SASSP 0129

CLASS 01 39

51502

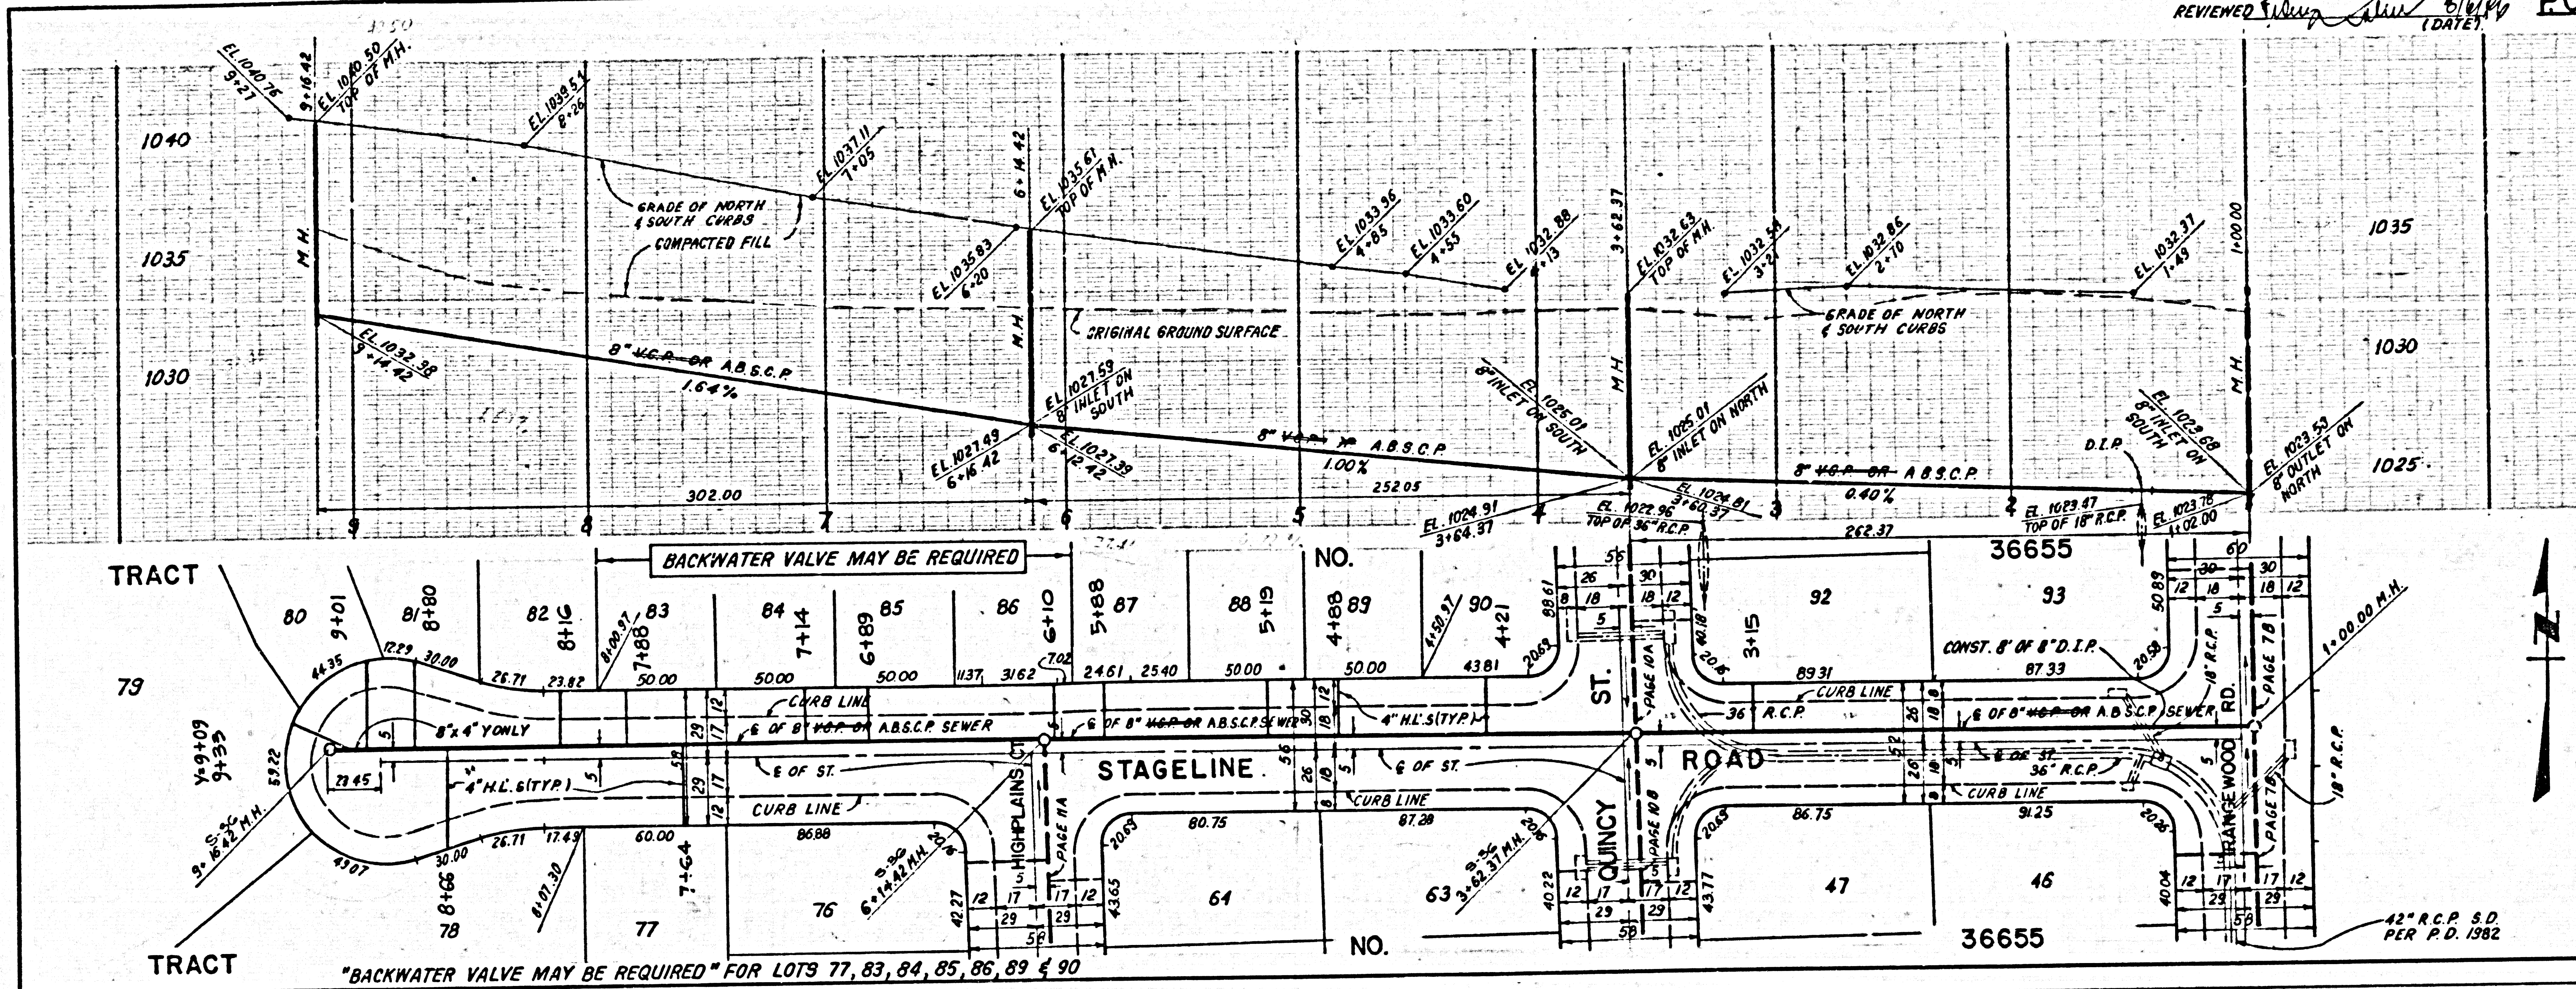
"BACKWATER VALVE MAY BE REQUIRED" FOR LOTS 77, 83, 84, 85, 86, 89 & 90

51503

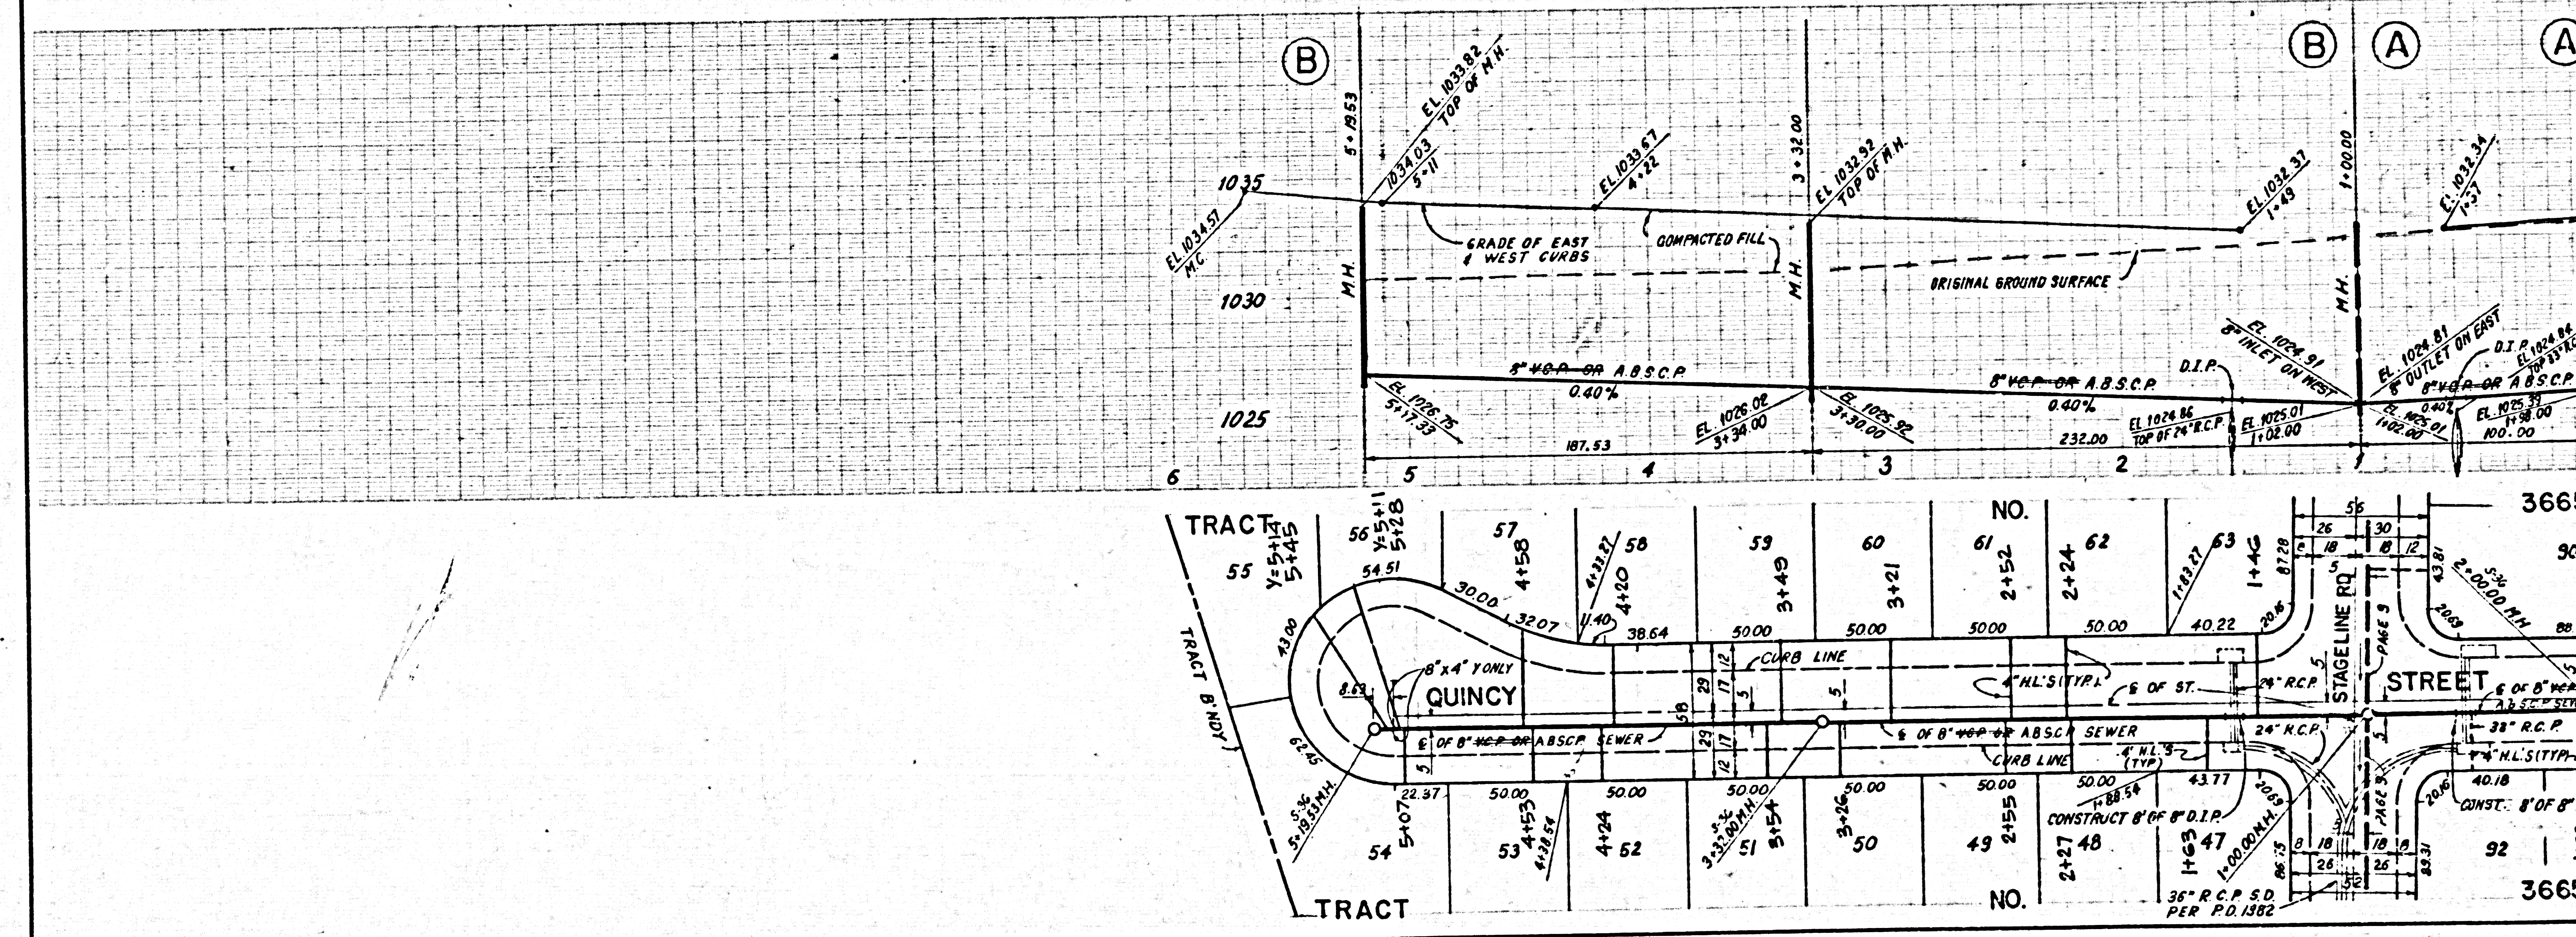
ISSUE NO PERMITS. M.H. MUST BE EXTENDED
